DEVELOPMENT PROJECT APPLICATION FORM

Project Name: Village of Pemberton Daycare

- A0.0 COVER PAGE
- A0.1 CONSTRUCTION ASSEMBLIES, ROOF PLAN
- A0.2 CODE REVIEW
- A0.3 SITE PLAN
- A0.4 SERVICES PLAN
- A1.0 OVERALL FLOOR PLAN
- A1.1 AREA PLAN
- A1.2 WINDOW & DOOR LEGENDS
- A2.0 OVERALL CRAWL SPACE PLAN
- A3.0 EXTERIOR ELEVATIONS
- A4.0 BUILDING CROSS SECTIONS
- A4.1 BUILDING WALL SECTIONS
- A4.2 STAIR & RAMP DETAILS
- A8.0 OVERALL RCP

PROJECT TITLE: VILLAGE OF PEMBERTON 7396B COTTONWOOD STREET DAYCARE		P22973	As indicated
DRAWING TITLE: CONSTRUCTION ASSEMBLIES, ROOF PLAN		DRAWN BY: RMM	DATE: 26 MAY 2023
		A0.1

DRAWING TITLE:
EXTERIOR ELEVATIONS

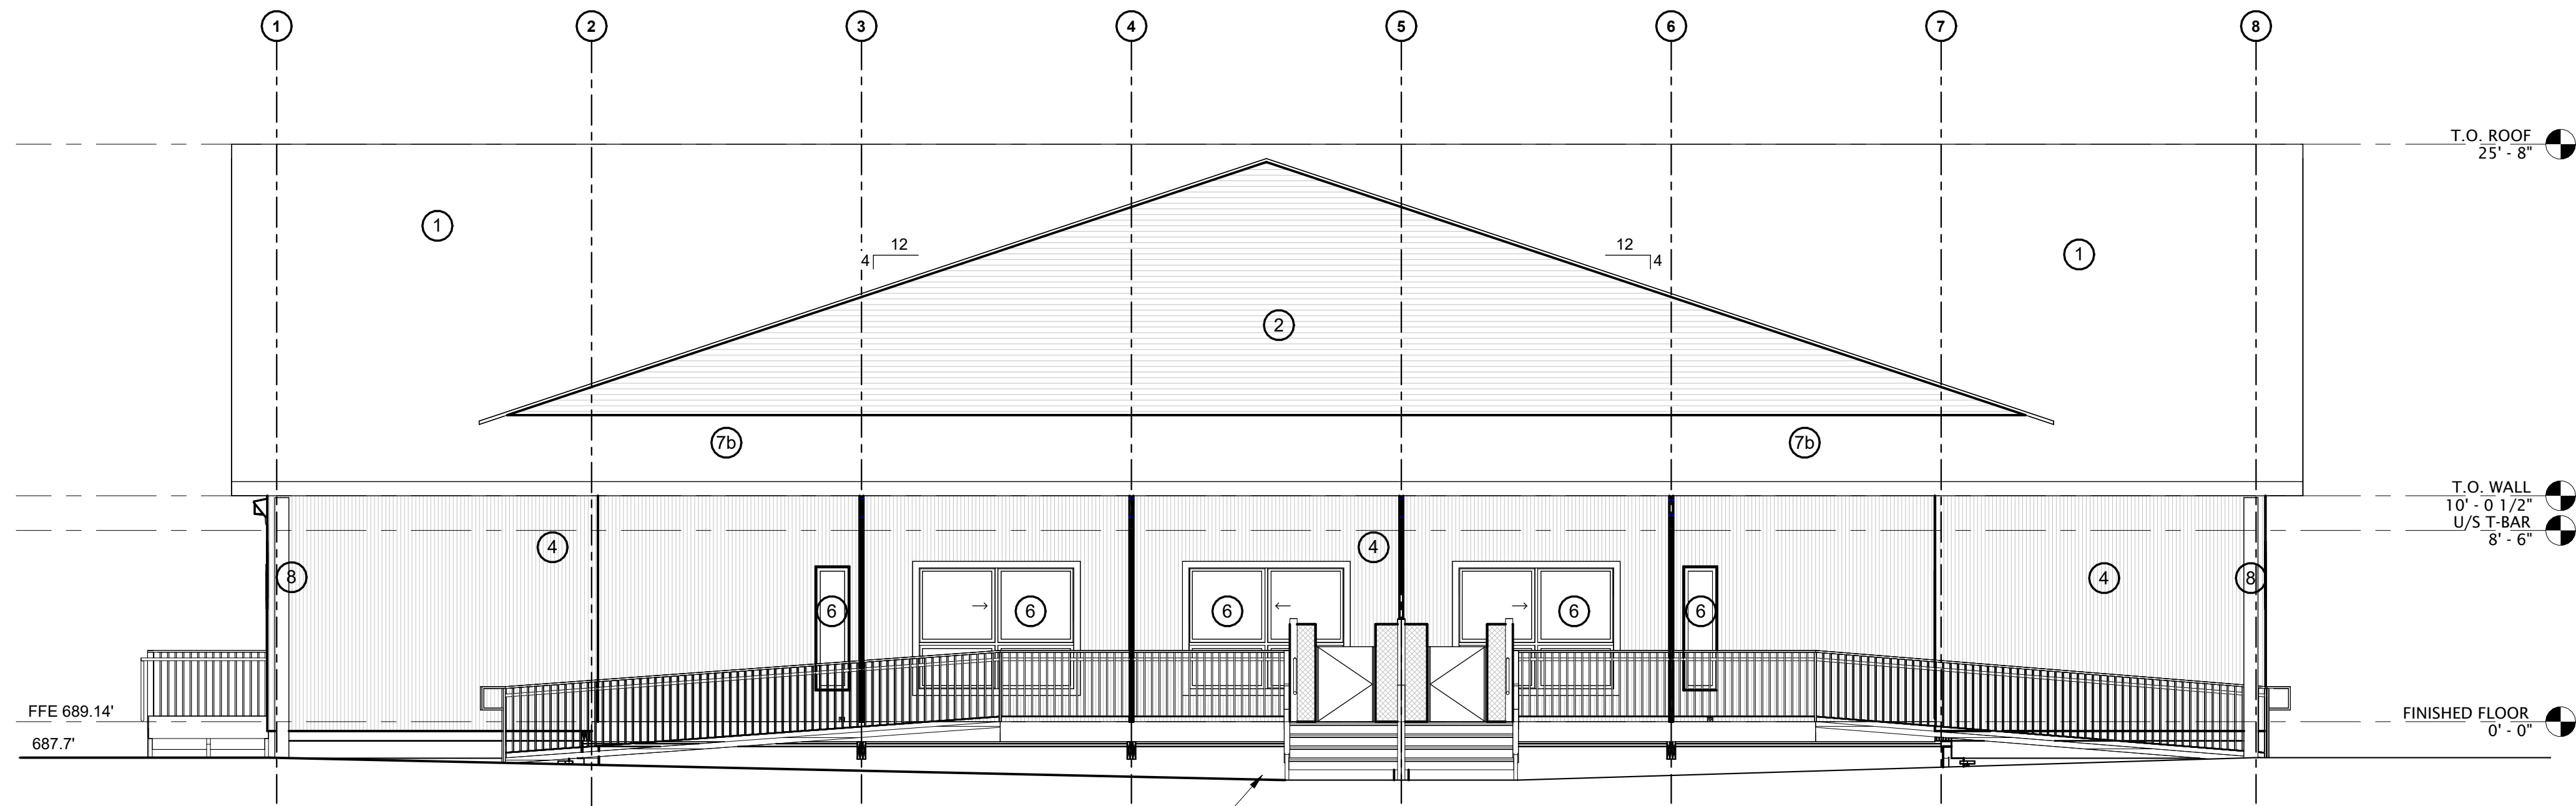
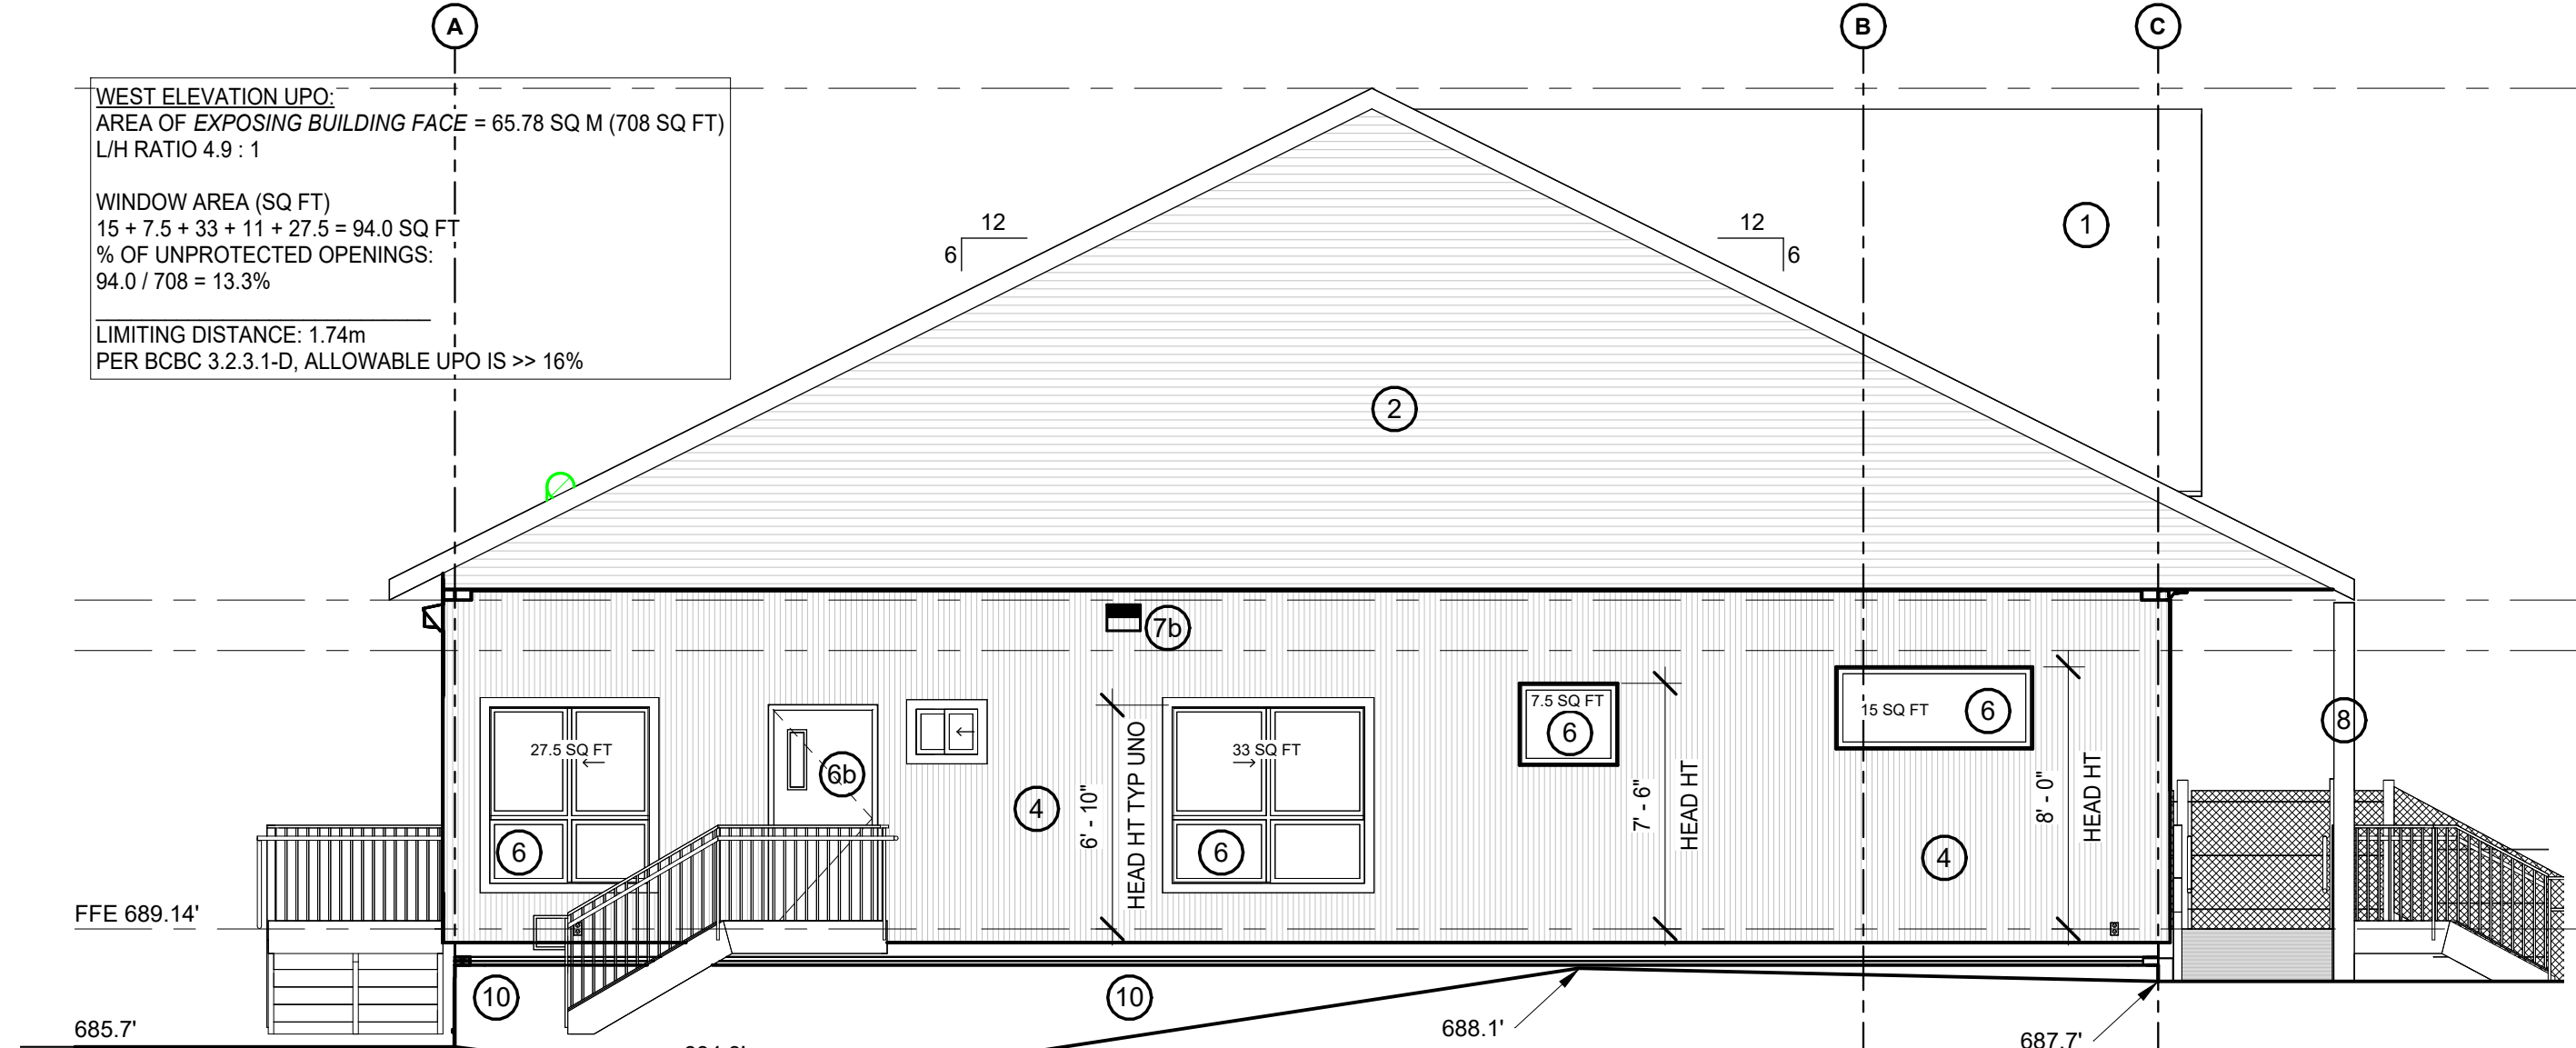
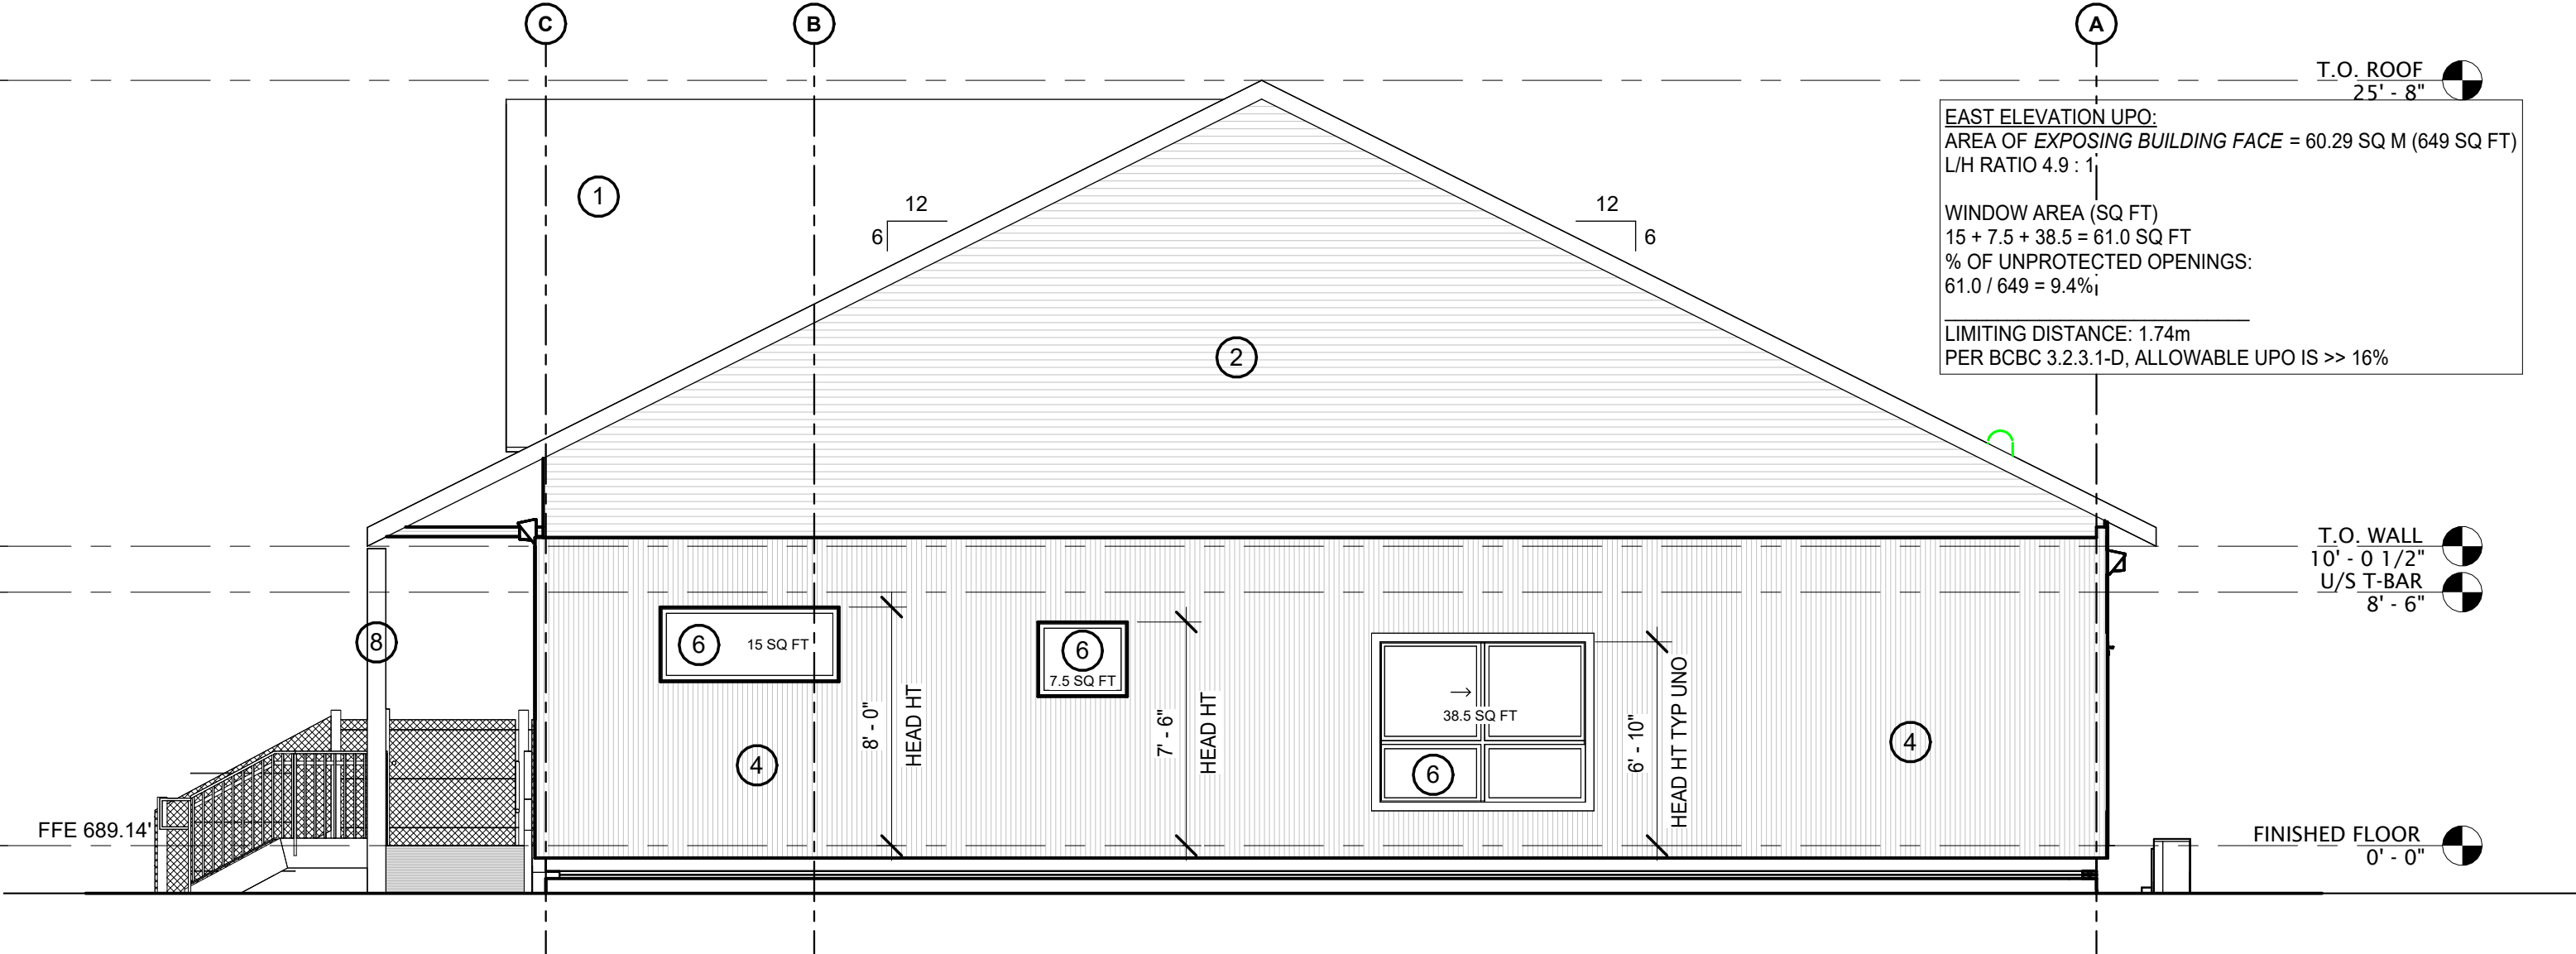
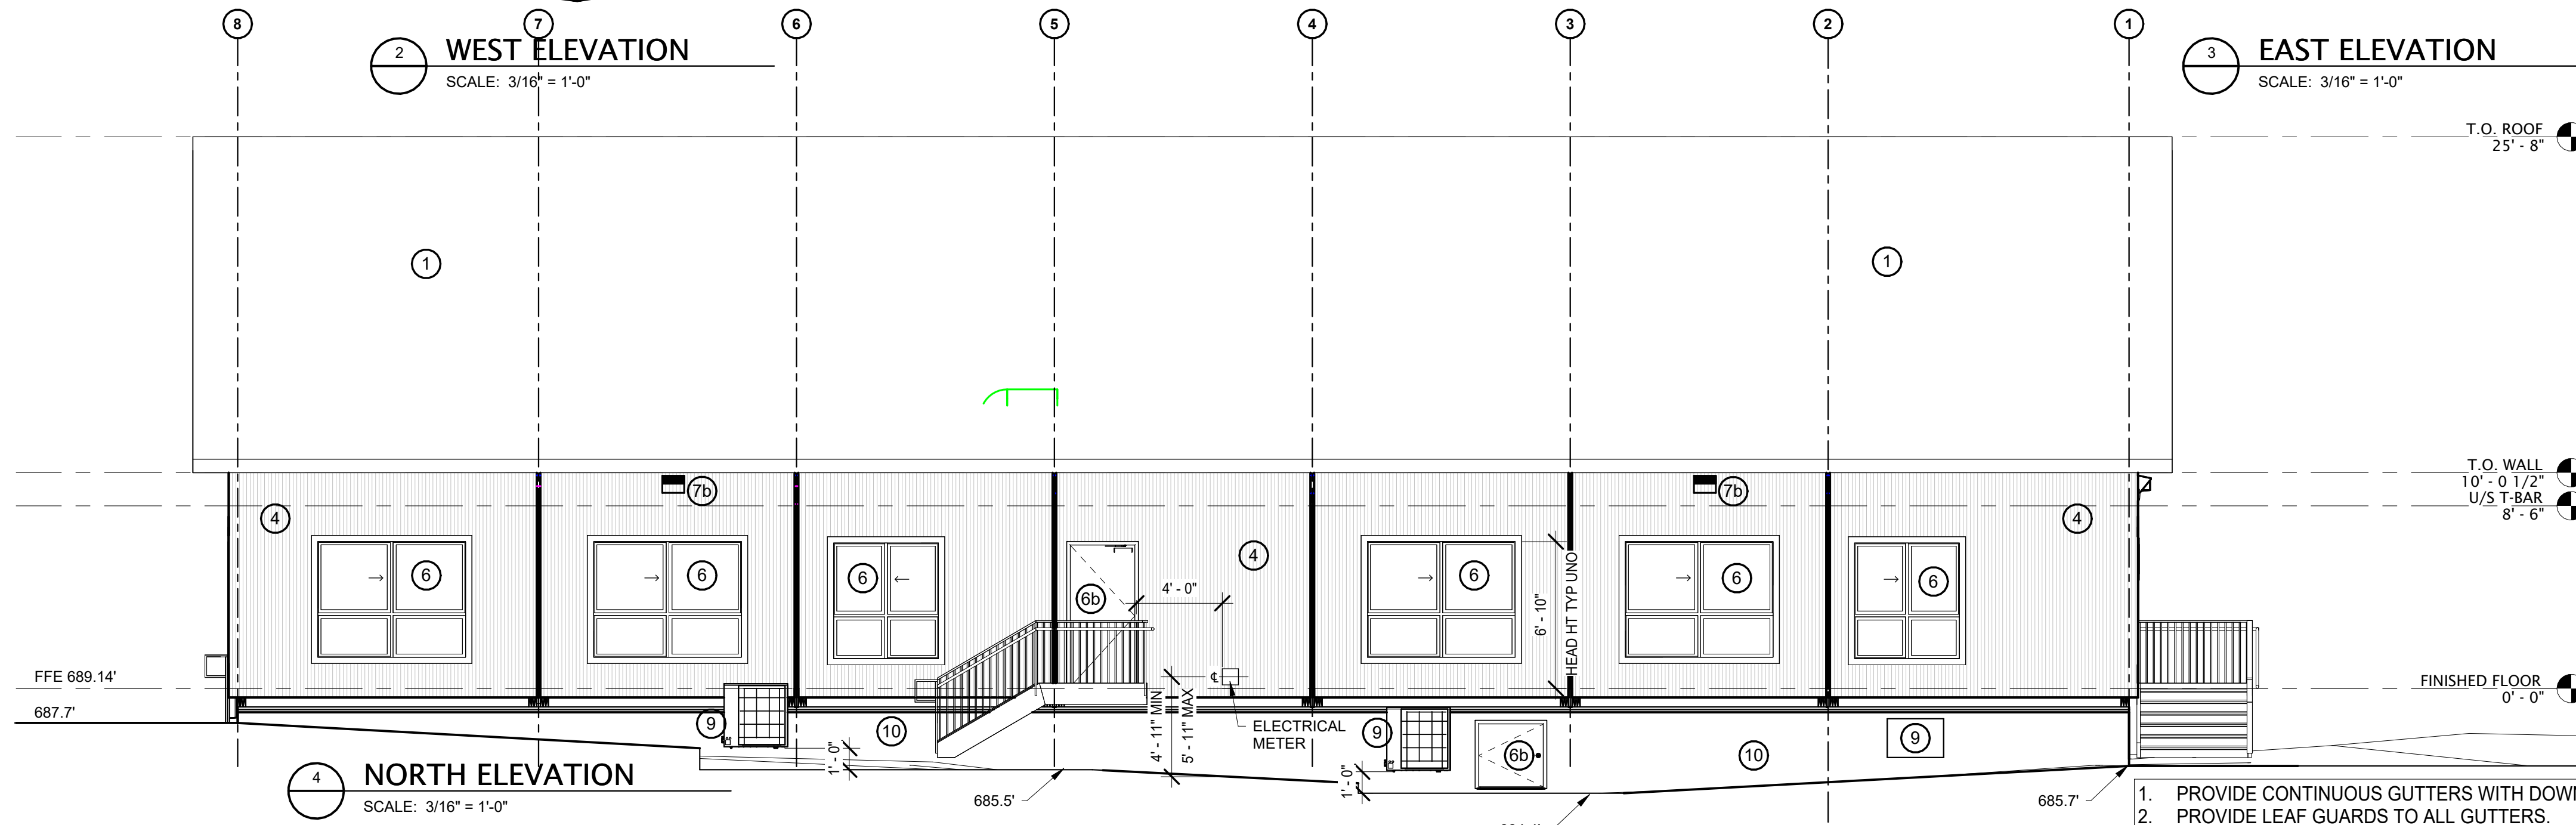
- WALL SYSTEMS SHALL COMPLY WITH RAIN SCREEN REQUIREMENTS. SECTION 5.6, DIVISION B, BCBC 2018.
- BUILDING ACCESSIBILITY INCLUDING STAIRS, RAMPS, LANDINGS, HANDRAILS AND GUARDS SHALL COMPLY WITH SECTION 3.8., DIVISION B, BCBC 2018 & THE BUILDING ACCESSIBILITY HANDBOOK 2020 (ILLUSTRATED COMMENTARY ON ACCESSIBILITY REQUIREMENTS).
- STAIRS, RAMPS, GUARDS & HANDRAILS SHALL COMPLY WITH 3.4.6., DIVISION B, BC BUILDING CODE.
- FIRE BLOCKING IN CONCEALED SPACES SHALL BE IN CONFORMANCE WITH 3.1.11., PART 3, DIVISION B, BCBC 2018.
